STAFF REPORT

PLANNING & ZONING COMMISSION
Village Green Municipal Building, Council Chambers
47 Hall Street
Wednesday, May 26, 2021
7:00 P.M.

Applicant: Christian Brothers Automotive
Location: 285 W Olentangy St
Existing Zoning: PC – Planned Commercial District
Request: Review of a Sketch Plan for a new automotive development on a ±1.5 acre site.

Exhibit 2.3: Mixed Use Village Center Detail

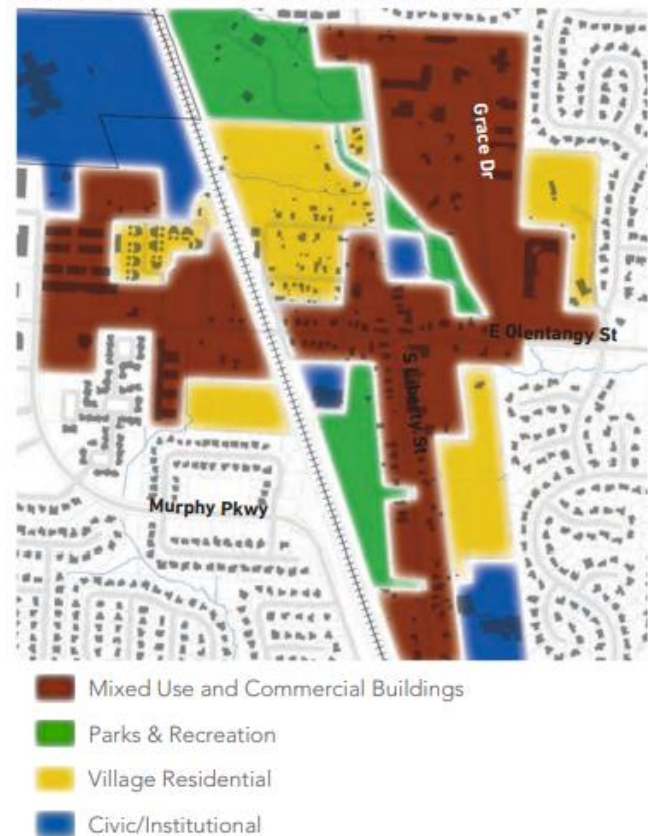
- Staff comment: The required setback is 60 feet from the West Olentangy Street right-of-way per the zoning code, while the proposal meets this setback requirement, the established development pattern for new structures indicates a prominent presence closer to the street. The wide drive aisle along the West Olentangy Street frontage limits the building location closer to the street, and Staff recommends the applicant study the proposed circulation pattern to potentially eliminate this drive aisle. The Fire Department will need to be consulted.

Although the main building entrance is clearly defined, it is located on the east elevation and therefore not prominent from the street frontage. Additionally, the proposed north elevation makes little attempt to simulate the appearance of a front presence.
